MITIGATION PLAN FINAL

Bridgefork Dairy Mitigation Site

Re: NCIRT Review and USACE Approval of the NCDMS Bridgefork Dairy Mitigation Site /
Cleveland County

The purpose of this letter is to provide the North Carolina Division of Mitigation Services (NCDMS) with all comments generated by the North Carolina Interagency Review Team (NCIRT) during the 30-day comment period for the Bridgefork Dairy Draft Mitigation Plan, which closed on August 20, 2022. These comments are attached for your review.

1.2.3

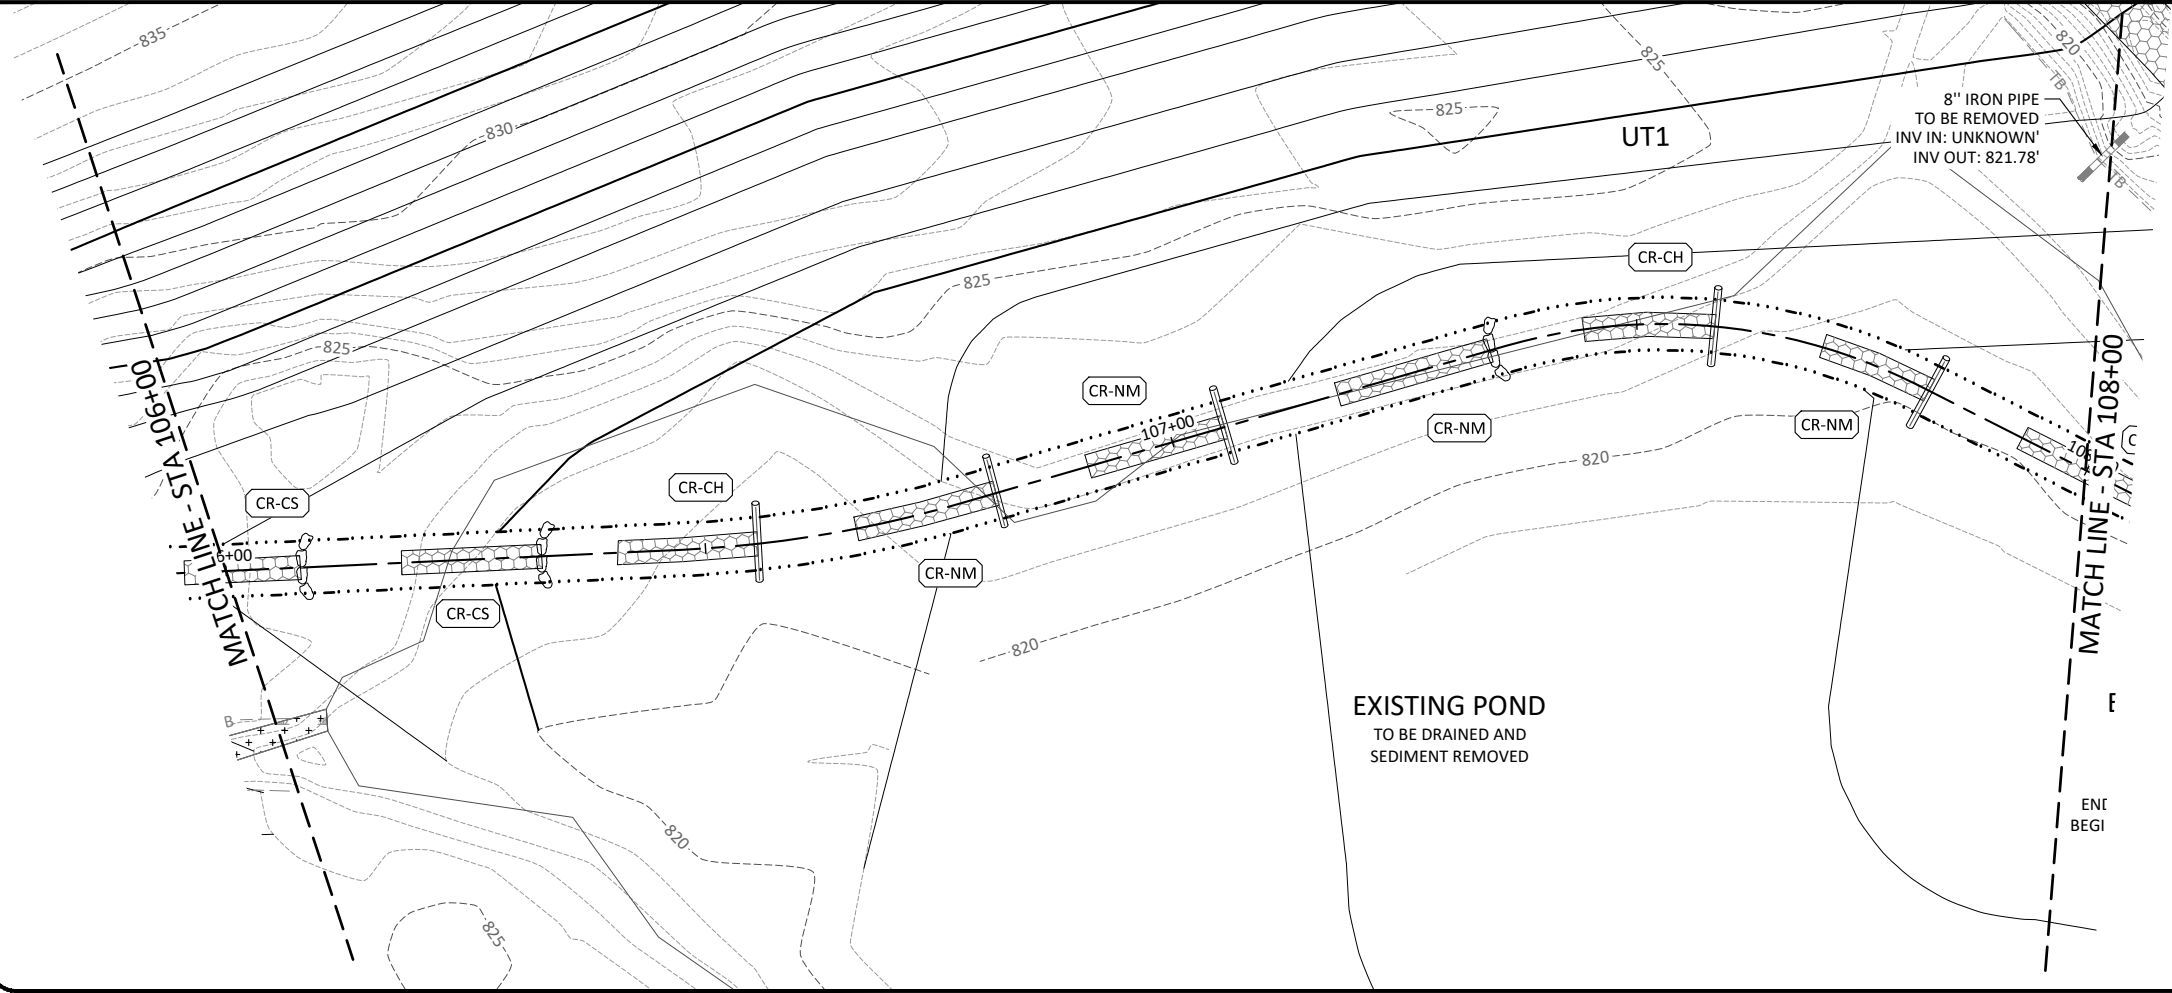
26. Sheet 1.2.3 – Please confirm with USACE, but I don't believe a vernal pool and stone outlet BMP can be excavated out of an existing jurisdictional wetland area.

3. Page 34 and Sheet 1.2.3: The shallow vernal pool/retention pond and stone outlet cannot be placed in a jurisdictional area.
4. At the IRT site visit, the IRT questioned whether UT4 would remain stable after the extensive removal of invasives with an EII approach and requested cross sections on this reach.

- *Ditches/old channel will be filled as part of the project. No partial backfilling or plugging of channels/ditches will be done at the Site.*
- 26) Sheet 1.2.3 – Please confirm with USACE, but I don't believe a vernal pool and stone outlet BMP can be excavated out of an existing jurisdictional wetland area.

3. Page 34 and Sheet 1.2.3: The shallow vernal pool/retention pond and stone outlet cannot be placed in a jurisdictional area.
 - *All vernal/floodplain pools and associated outlets were removed from jurisdictional wetland features.*

1.5.2

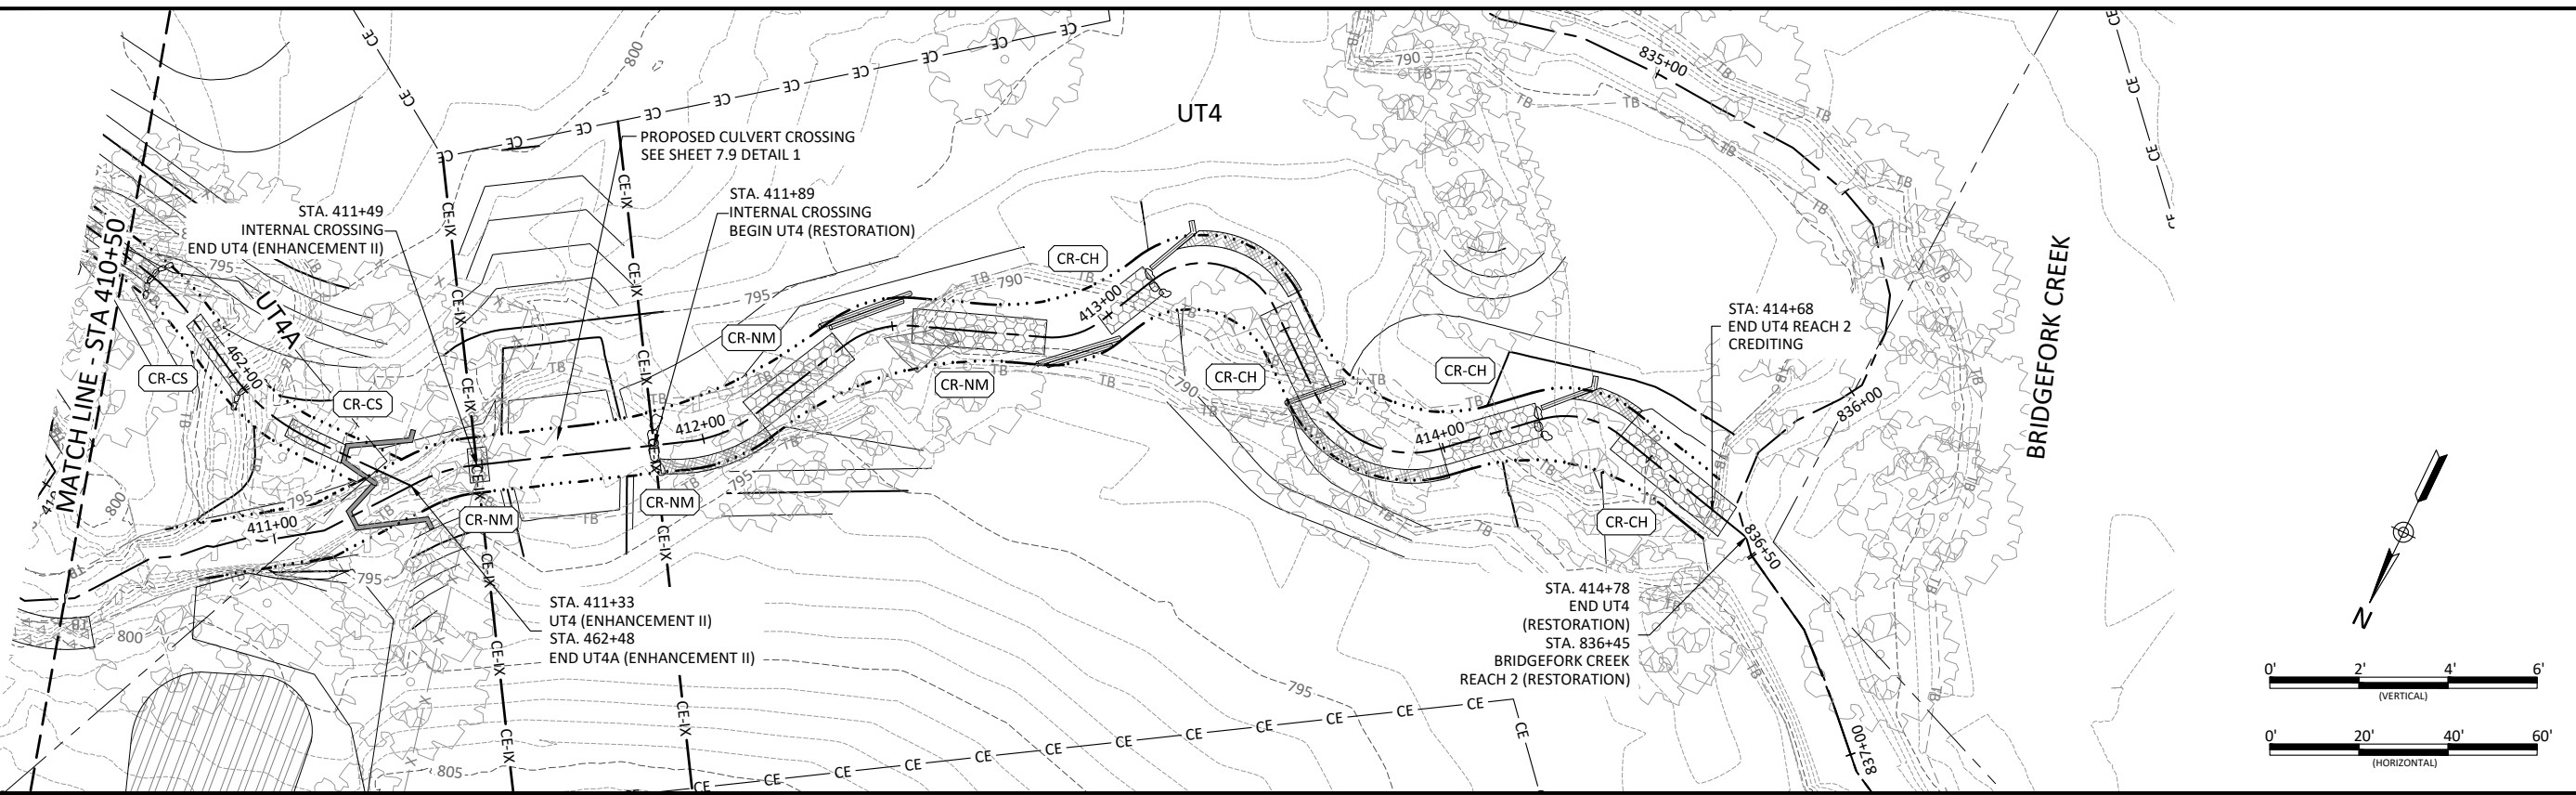
- Description indicates that EII work will consist of invasive species management and debris removal. Section 11.0 Determination of Credits states that the 2.5:1 EII ratio will include cattle exclusion and minor bank grading as well. Recommend revising section 6.6.8 and discuss bank grading activities. Also, please add locations of bank grading and debris removal (if isolated areas) to sheets 1.5.1 and 1.5.2.

- *Description indicates that EII work will consist of invasive species management and debris removal. Section 11.0 Determination of Credits states that the 2.5:1 EII ratio will include cattle exclusion and minor bank grading as well. Recommend revising section 6.6.8 and discuss bank grading activities. Also, please add locations of bank grading and debris removal (if isolated areas) to sheets 1.5.1 and 1.5.2.*

- a) *Enhancement measures along UT4 including bank grading, debris removal, and intensive invasive treatment were added to the design plans (Sheets 1.5.1 and 1.5.2) to support the proposed 2.5:1 credit ratio. A monitoring cross section was added along the reach where bank grading will occur, per IRT request.*

1.6.2

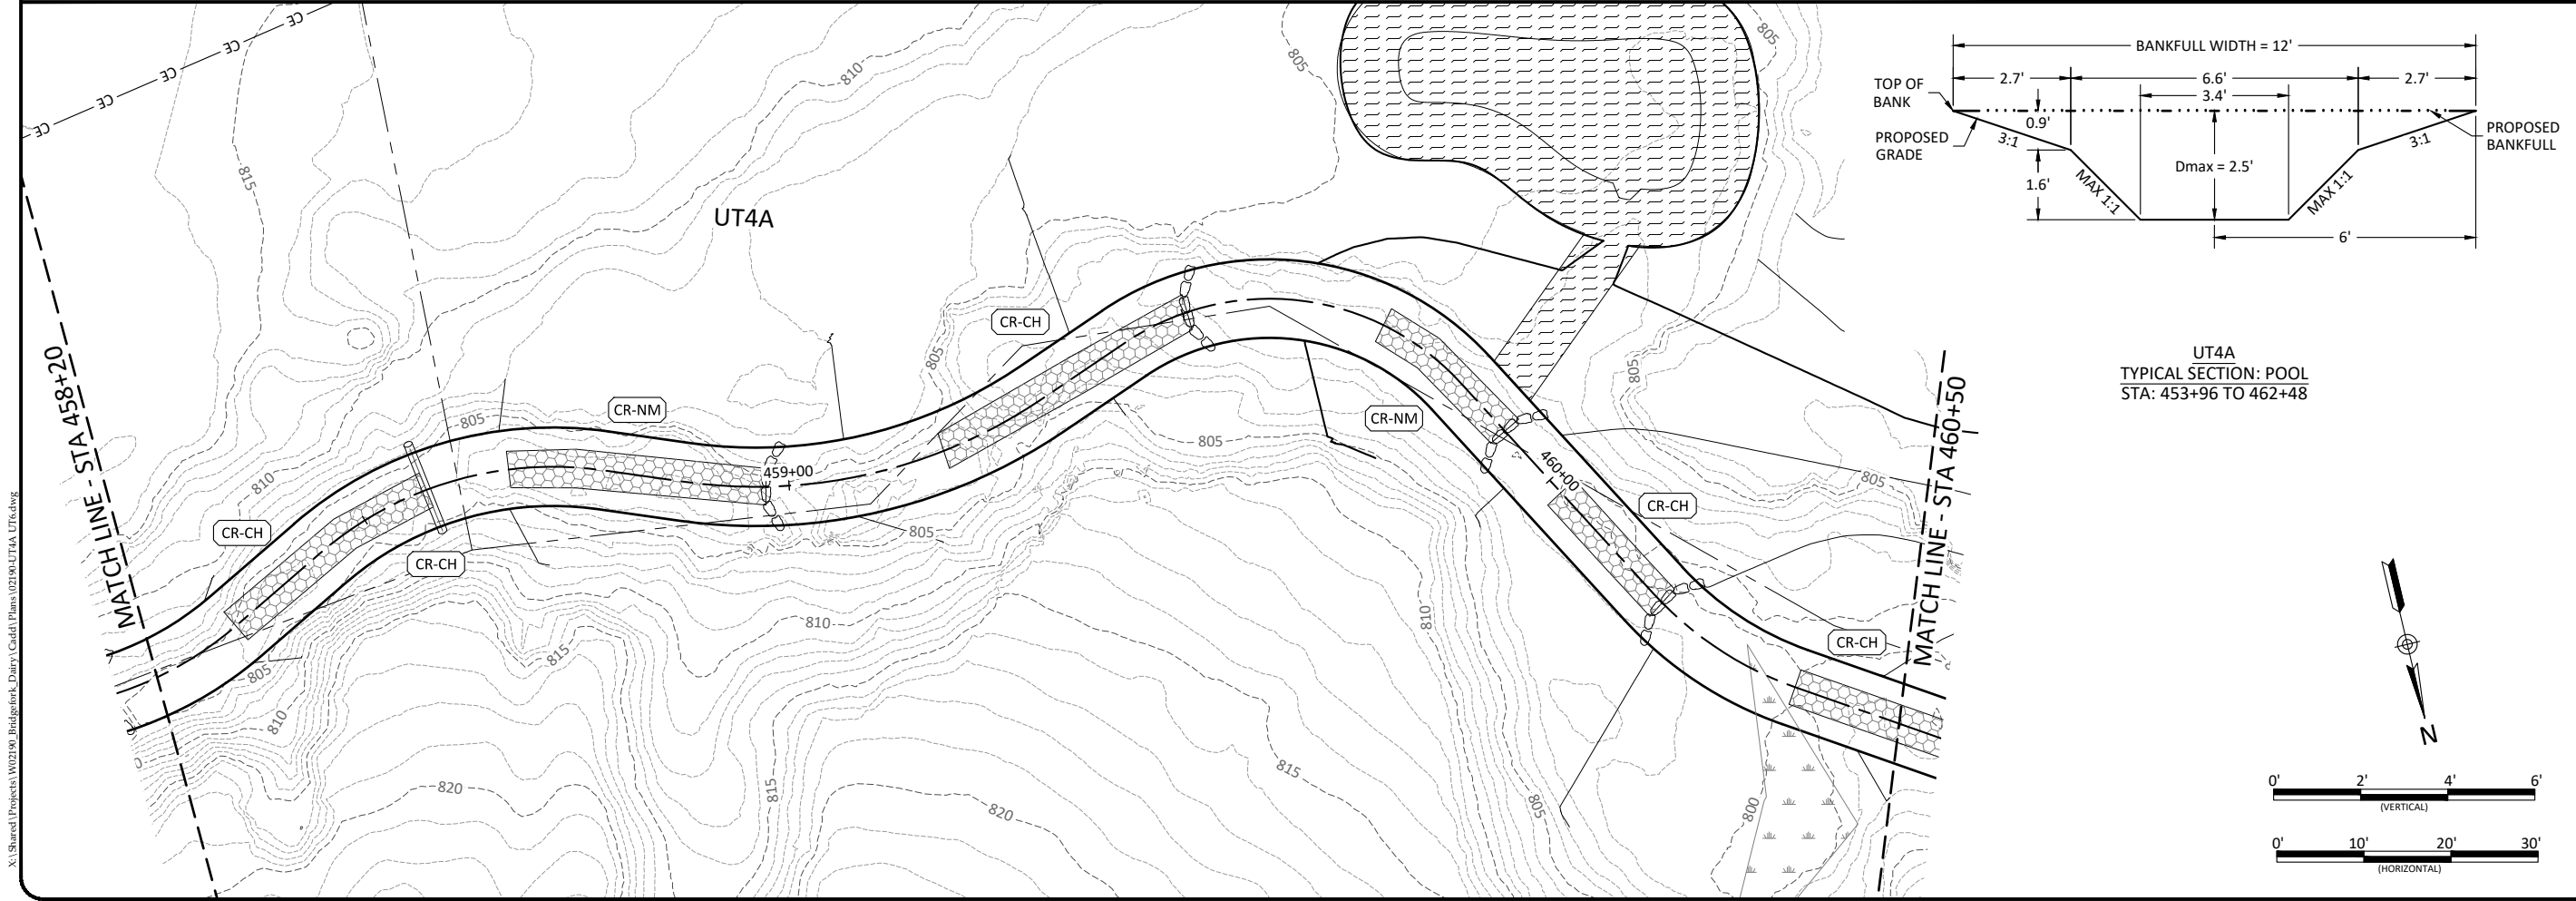
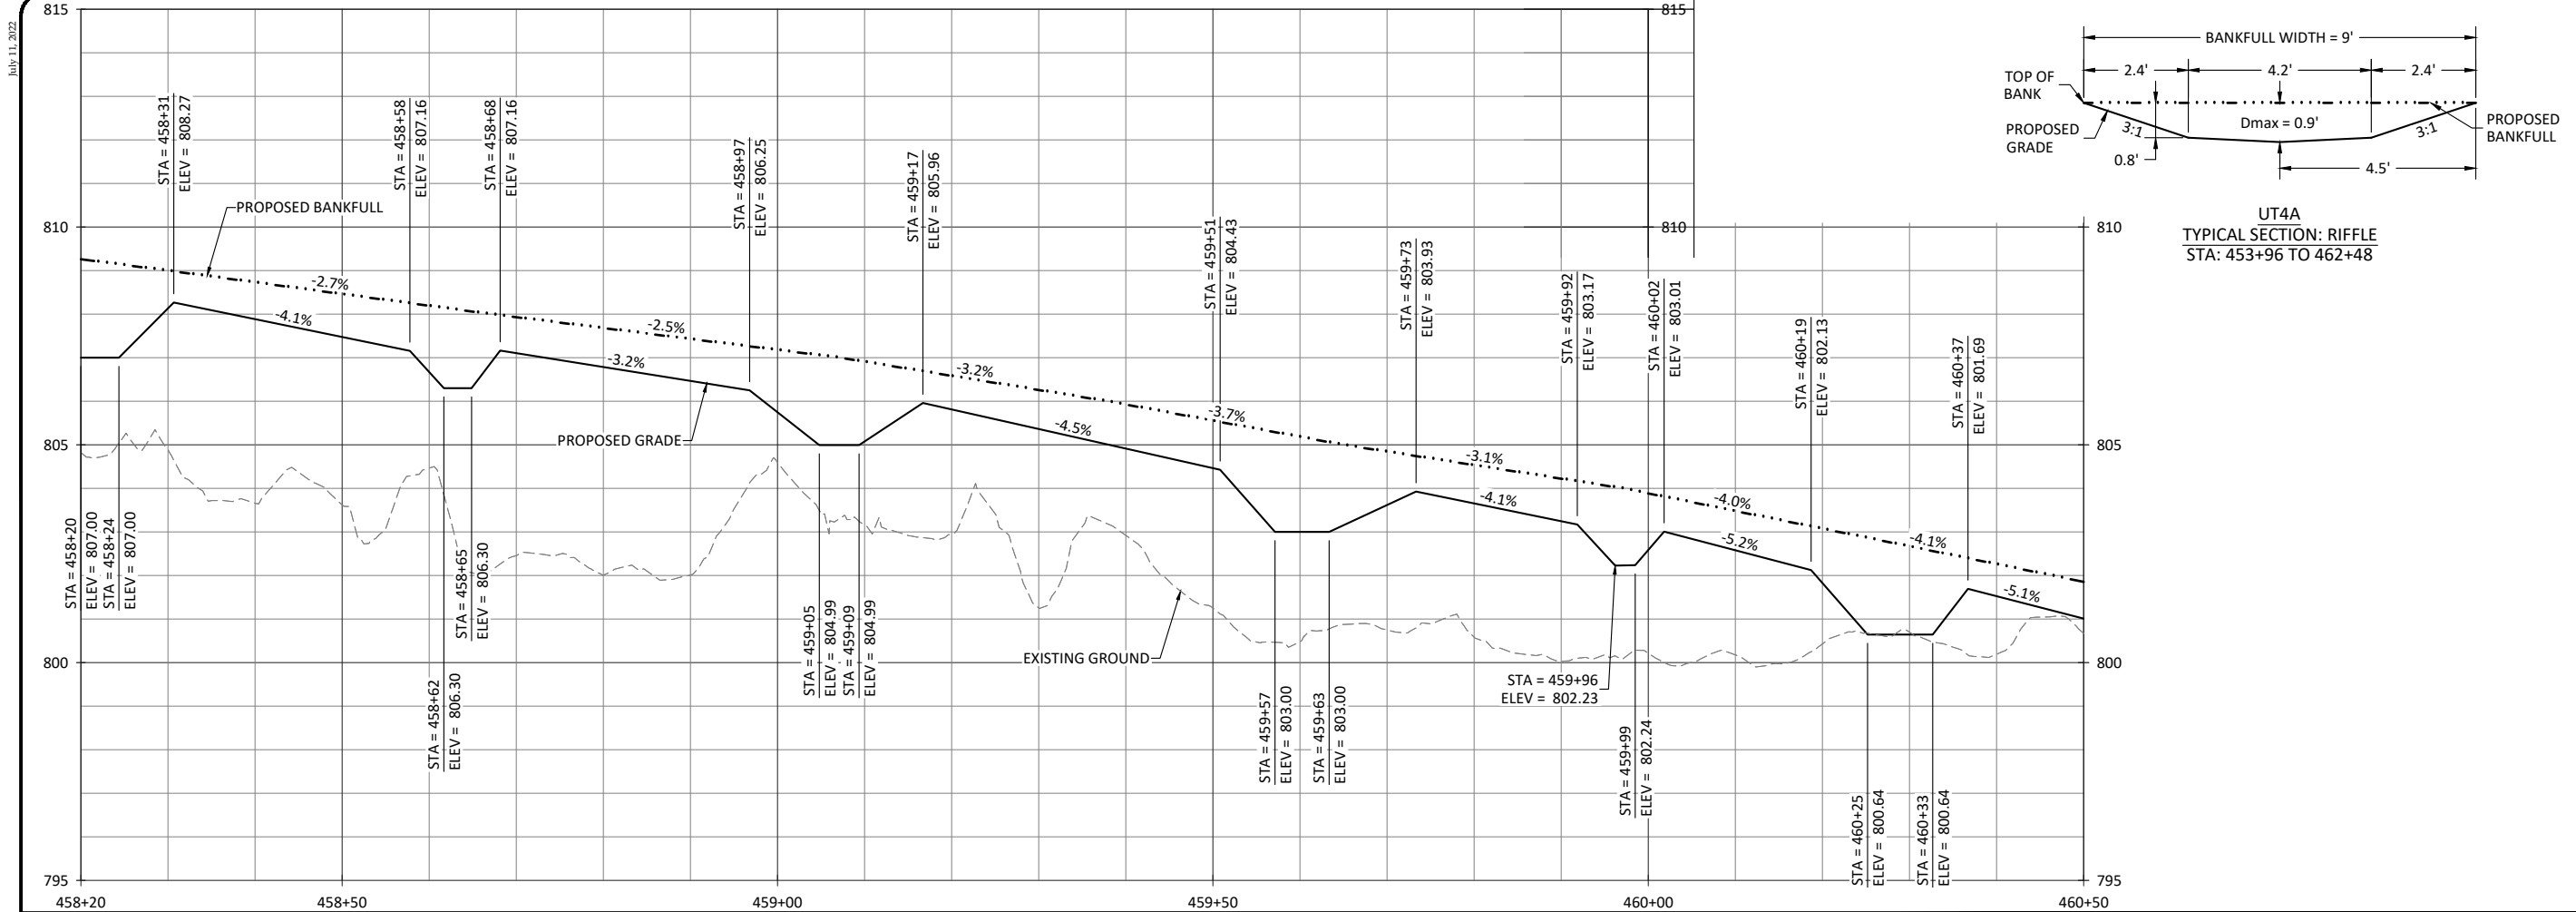
- Two vernal pools are shown on this reach (sheet 1.6.4 and 1.6.5). Same comment as above.
- Recommend referring to BMP as BMP 1 as shown on sheet 1.6.2.

- *Two vernal pools are shown on this reach (sheet 1.6.4 and 1.6.5). Same comment as above.*
 - See above response to comment regarding Section 6.6.5.
- *Recommend referring to BMP as BMP 1 as shown on sheet 1.6.2.*
 - Text has been revised to refer to the BMP in this discussion as BMP 1. BMP 1 has been labeled in the figures.
